Access Compliance Report

Public Rights-of-Way

Intersection ID: 15515	Main Street: BERKSHIRE_RD	Cross Street: LAWNDAL RD	Location:	N
ADA ID: 2DBBC49D8466	Ramp Type: PerpDiag	Initial Pass/Fail: Fail	Overall Compliance: No	Severity Score: 48.75
Codes/Mitigation Info/Possible Solution		Field Measurements/Component Compliance

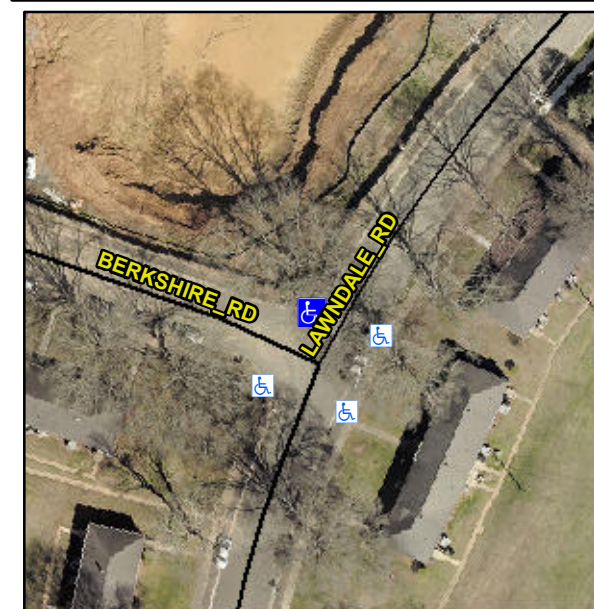
Not Found, R304.5.1, R304.2.2, R302.7

Compliance	Description	Data	Compliance	Description	Data
N/A	Ramp Length (in)	46.0	No	Ramp Slope (%)	13.2
No	Ramp Width (in)	45.0	Yes	Ramp XSlope (%)	1.9
N/A	Flare Type LT	N/A	N/A	Flare Type RT	N/A
N/A	Flare Slope LT (%)	N/A	N/A	Flare Slope RT (%)	N/A
N/A	Flare Traversable LT?	N/A	N/A	Flare Traversable RT?	N/A
N/A	Landing Length (in)	N/A	N/A	DWS Provided?	N/A
N/A	Landing Width (in)	N/A	N/A	DWS Contrast?	N/A
N/A	Landing Slope (%)	N/A	N/A	DWS Length (in)	N/A
N/A	Landing X Slope (%)	N/A	N/A	DWS Full Width?	N/A
N/A	Landing Curb? (Y/N)	N/A	N/A	DWS Offset (in)	N/A
N/A	Shared Landing?	N/A			
N/A	Gutter Ponding?	N/A	N/A	Gutter Slope (%)	N/A
N/A	Gutter Lip Ht (in)	N/A	N/A	Gutter X Slope (%)	N/A
N/A	Painted X Walk1?	No	N/A	Painted X Walk2?	No
	X Walk 1 Direction	To SW		X Walk 2 Direction	To SE
N/A	X Walk 1 Width (in)	N/A	N/A	X Walk 2 Width (in)	N/A
	X Walk 1 Slope (%)	9.0		X Walk 2 Slope (%)	4.9
	X Walk 1 X Slope (%)	1.0		X Walk 2 X Slope (%)	2.3

N/A	Ramp inside XWalk1?	N/A	N/A	Ramp inside XWalk2?	N/A
	Road Slope (%)	2.8	N/A	Clear Space?	N/A
	Road X Slope (%)	4.5	N/A	Clear Space to XWalk (in)	N/A
N/A	Any Obstructions?	N/A	N/A	Storm Grate/Utility Hazard?	N/A
	Obstruction Type			Storm Grate/Utility Type	
		N/A			N/A
		No		Surface Condition? (G/P)	Poor

Remove & Replace Curb Ramp With Two New Directional Ramps or Equivalent.
